Addendum No. 01

Subject: GIRARD ACADEMIC MUSIC PROGRAM (GAMP)
SCIENCE LAB RENOVATIONS
SDP Contract Nos. B-124C, B-125C, B-126C, and B-127C of 2017/2018

This Addendum, dated 1st of May, 2019, shall modify and become part of the Contract Documents for the work of this project. Any items not mentioned herein, or affected by, shall be performed strictly in accordance with the original documents.

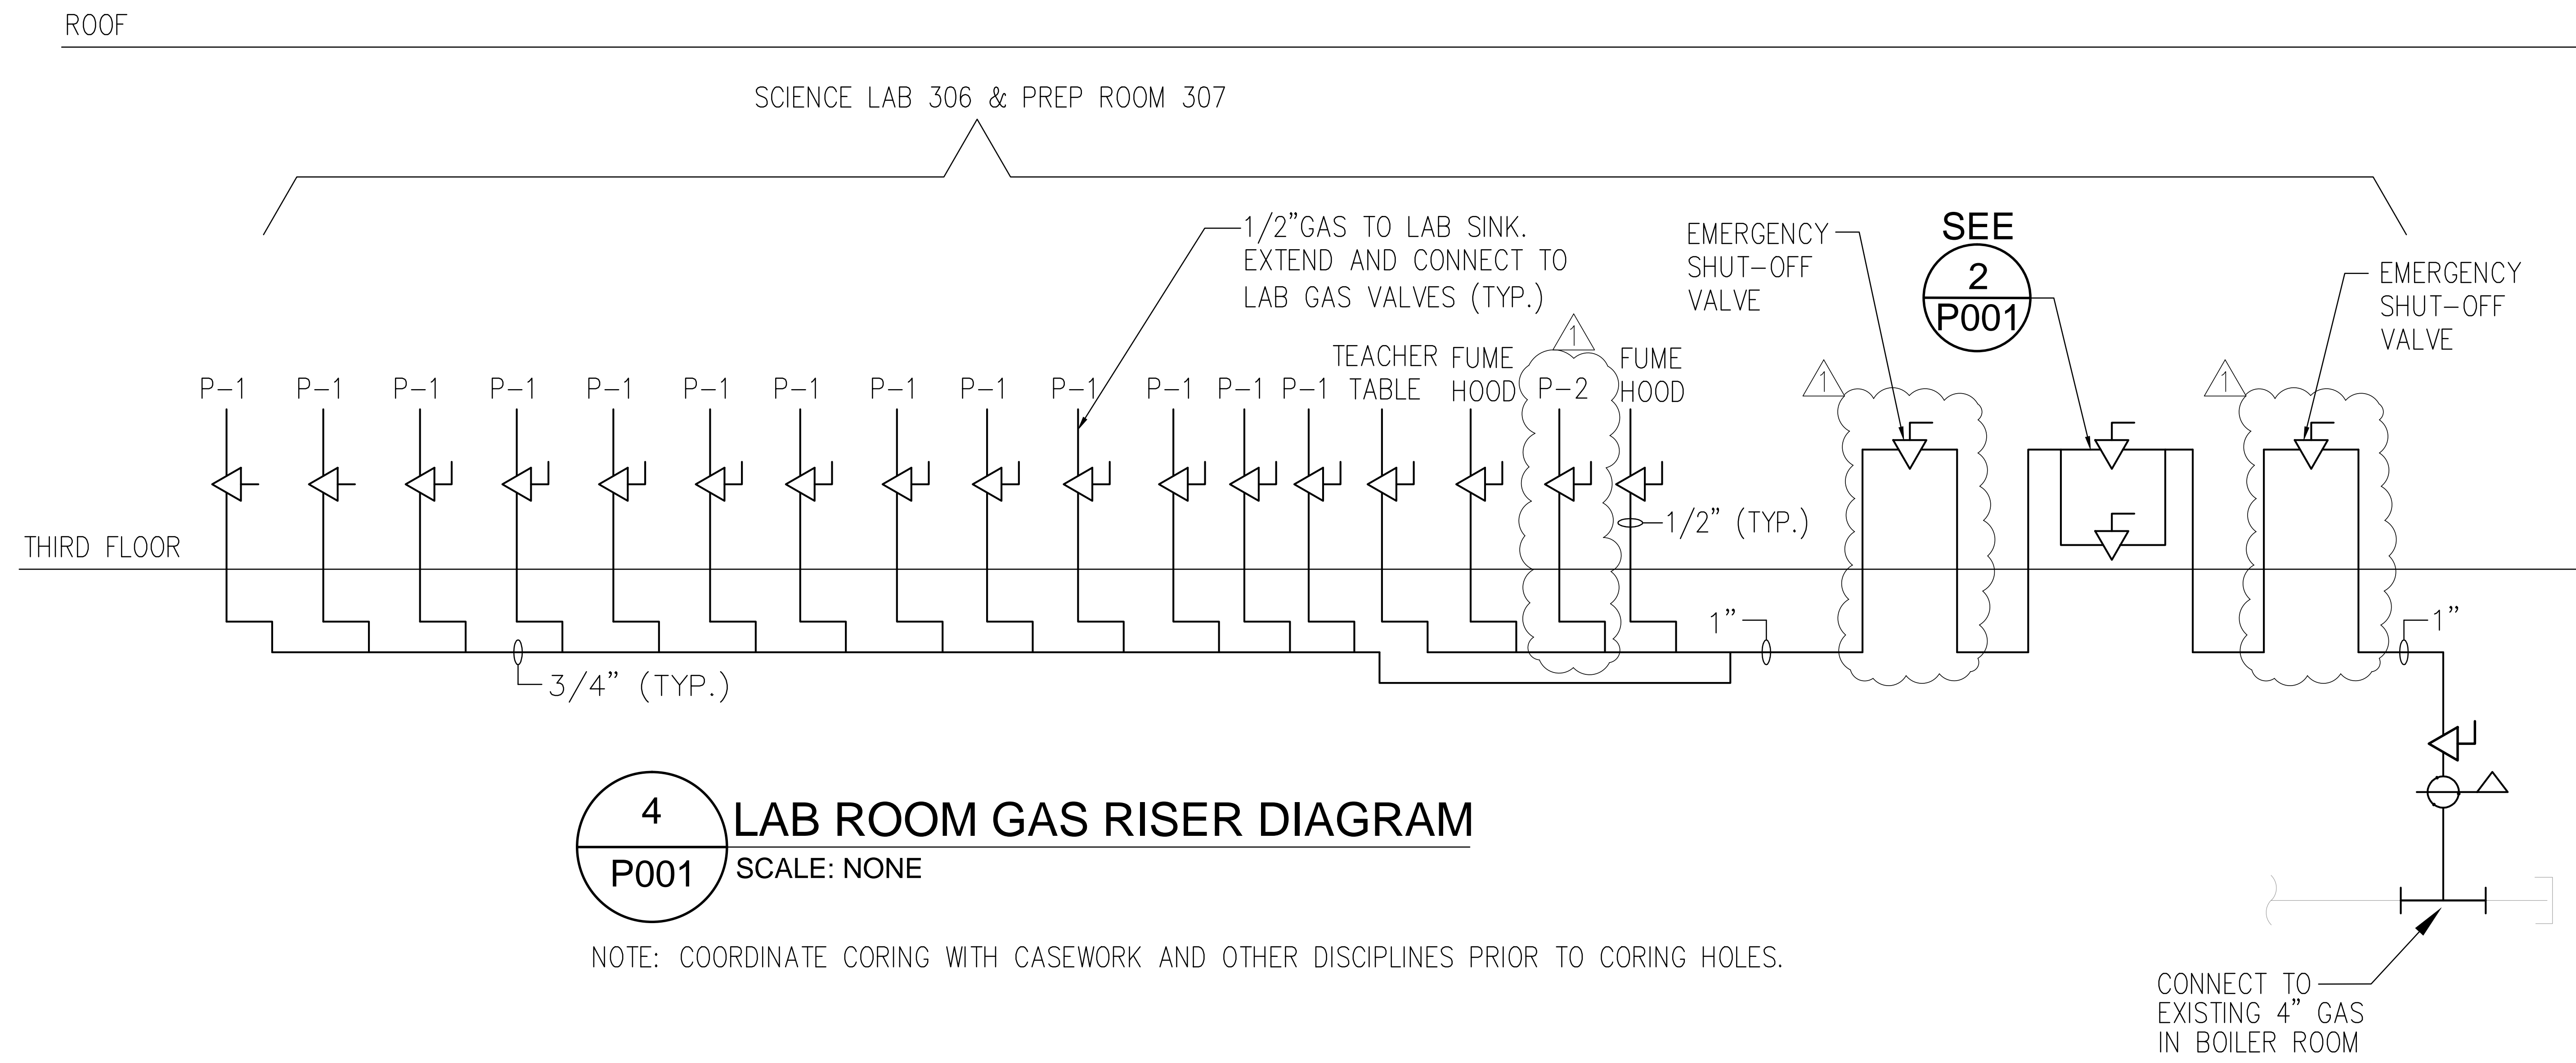
ASK-P1 dated 4/30/19 modifies detail 4/P001.0
ASK-P2 dated 4/30/19 modifies plan 2/P103.0
ASK-P3 dated 4/30/19 modifies plan 1/P103.0

10. Q: P-001.0 shows the gas risers into the lab tables to be 1/2" (typ), whereas P-103.0 shows them as 3/4".(typ). Which is correct?

A: Gas riser into the lab tables shall be 1/2".
